BUILDING 22

BUILDING GROUP F

AD-01

ADDENDUM 1: GROUP DEMOLITION ELEVATION

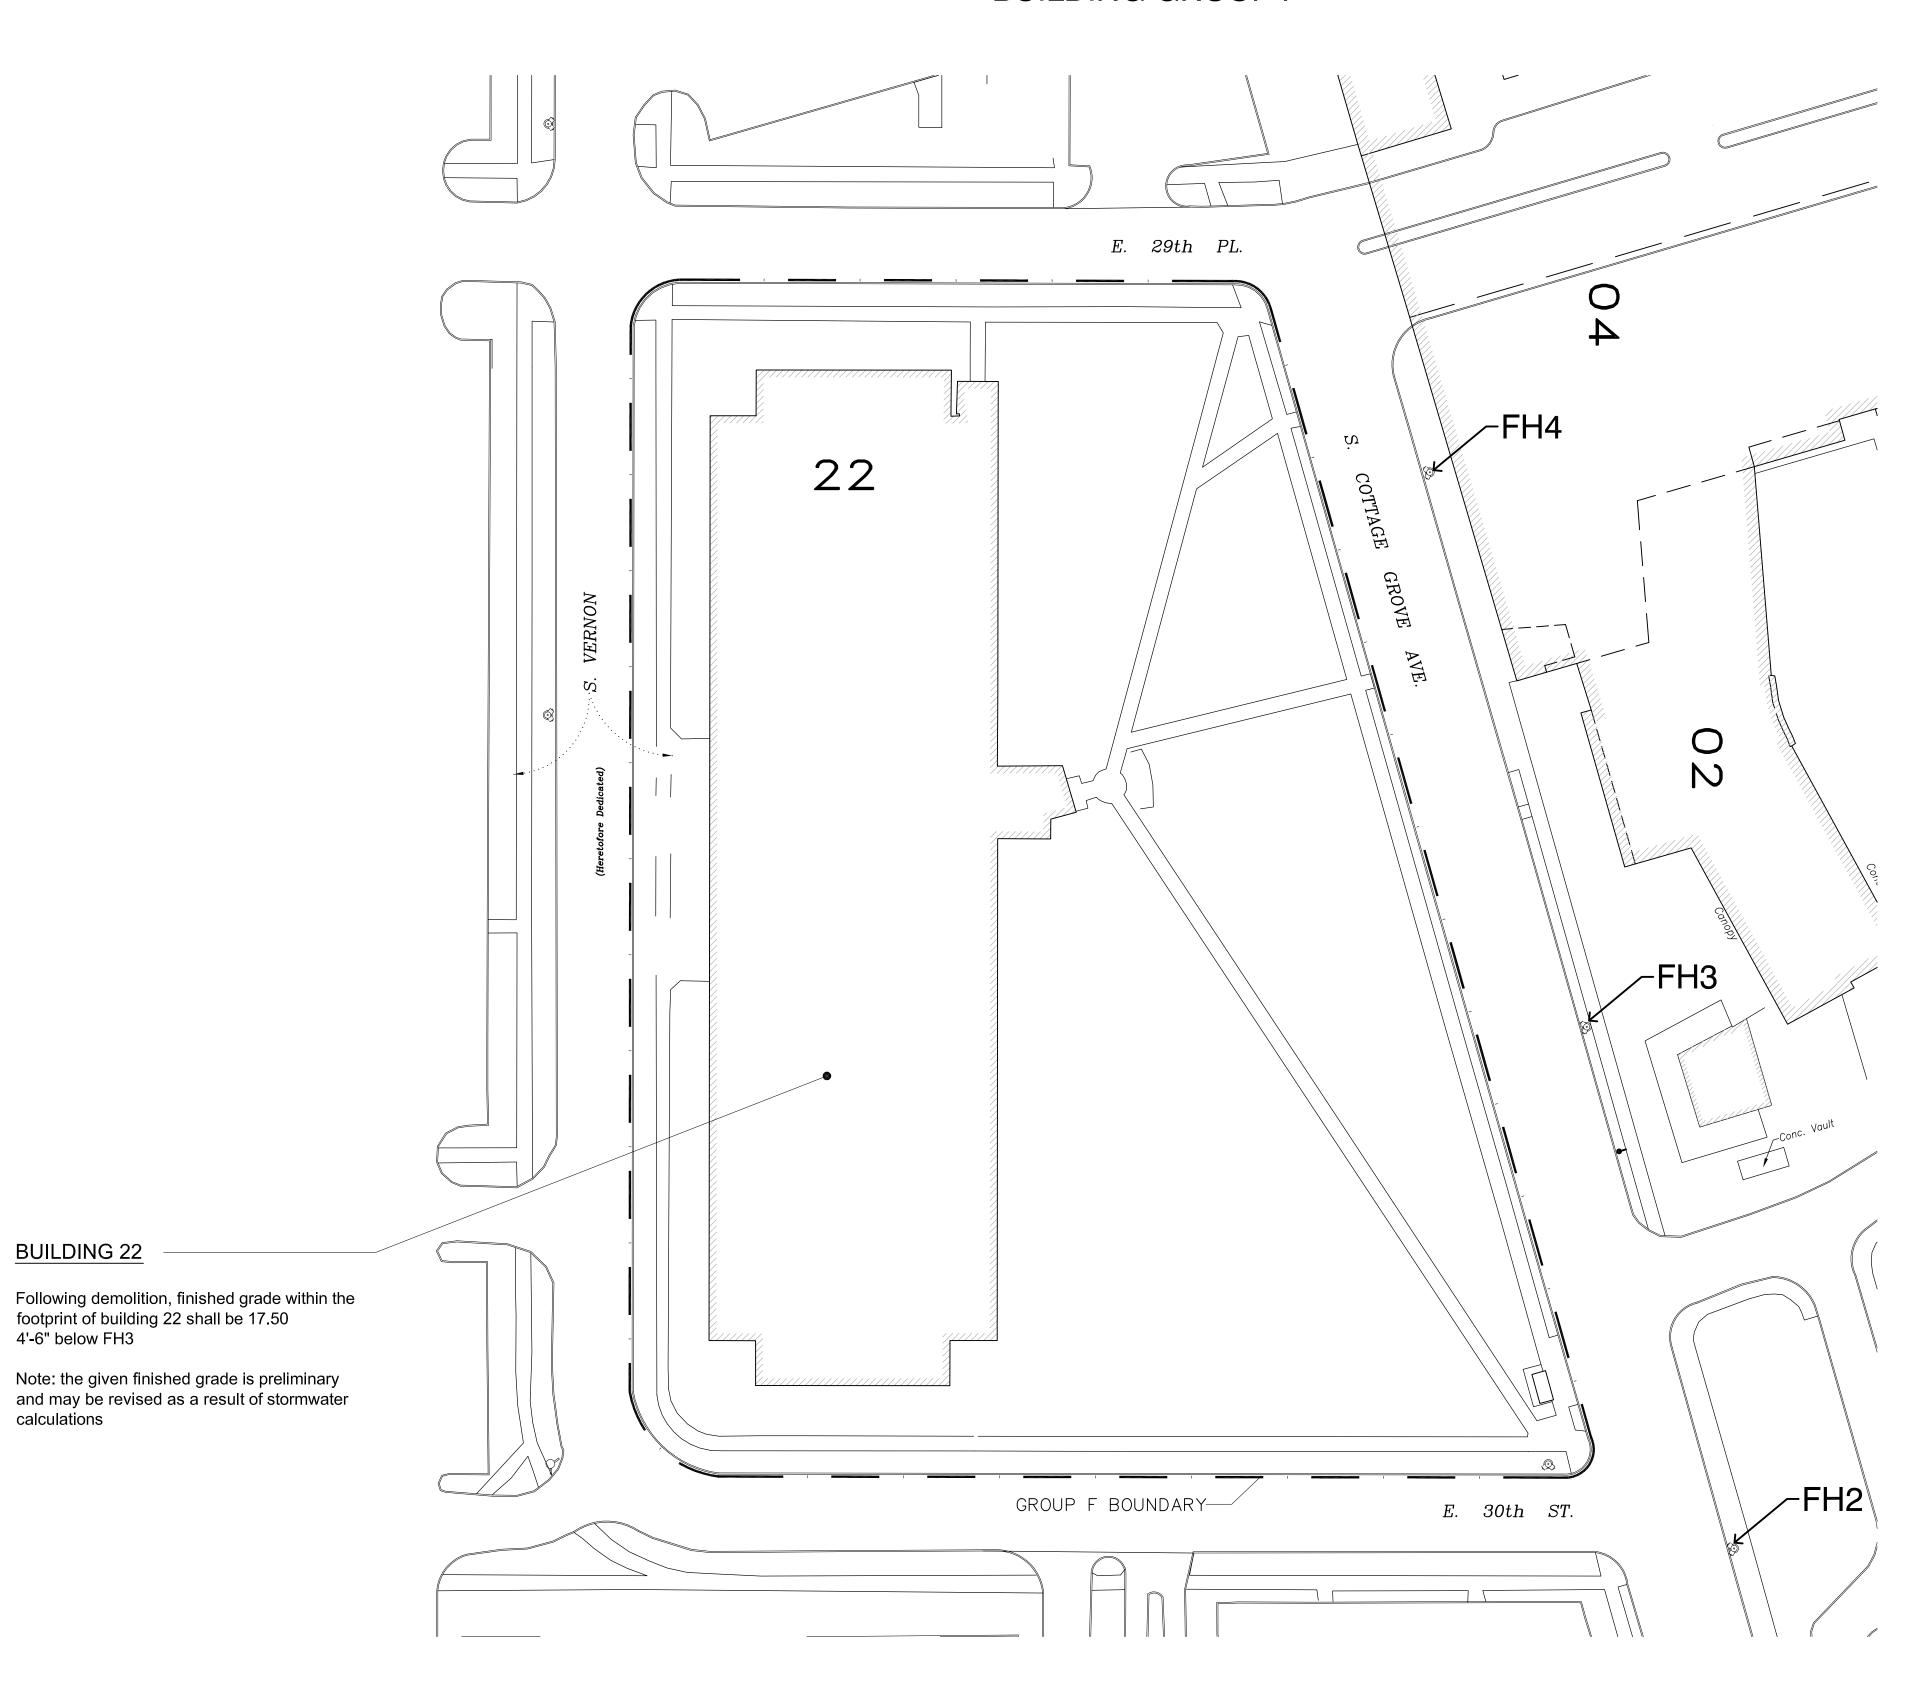
- 1. Contractor shall excavate bermed material around Building 22 to facilitate demolition of the structure. Excavation shall be done in a manner to prevent accumulation of stormwater and groundwater.

- 2. Stockpile excavated material in a location approved by Commission or their representative. Contractor is responsible for keeping the stockpiled materials which are classified differently separated within stockpiles. The Contactor shall place all stockpiled materials on 2 layers of 6 mil (minimum) thick plastic sheeting, cover with 6 mil plastic sheeting, and protect with 12-inch berms. The contractor shall not allow runoff from stockpiled materials to migrate to other areas, enter storm drains, or leave the site.

- 3. Following the demolition of the structure, return the stockpiled materials to the general location from which they originated and use to establish required grade elevations on the site in accordance with project requirements.

- 4. The contractor shall control dust during all excavation, stockpiling, and grading operations by all necessary means to minimize dust generation.
